Service Advisory

CC-685

iSERIES

Subject: **759-04284 Service Kit To Replace Cam Assemblies For The 618-04430 and 618-04634 Steering Gearboxes.**

FIGURE 1

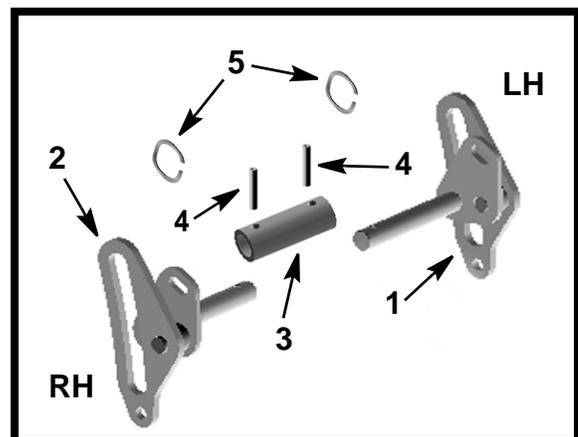
PURPOSE: This service kit provides the latest production RH and LH cam assemblies, steering cam connector tube and necessary hardware when replacing:

If only one of the cam assemblies or the steering cam connector tube is damaged, both new cam assemblies, new steering cam connector tube, wave washers and spring pins supplied must be replaced as a complete set. This kit is only applicable to iSeries riders with hydrostatic transmissions.

ITEM NO.	PART NUMBER	QTY	DESCRIPTION
1	647-04228	1	CAM: ASSEMBLY: LH: HYDRO
2	647-04229	1	CAM: ASSEMBLY: RH: HYDRO
3	718-04388A	1	TUBE: CONNECTOR: STRG CAM
4	715-0120	2	PIN: SPRING: SPIRAL
5	732-04711	2	WASHER: SPRING: WAVE
6	*	1	THIS INSTRUCTION SHEET
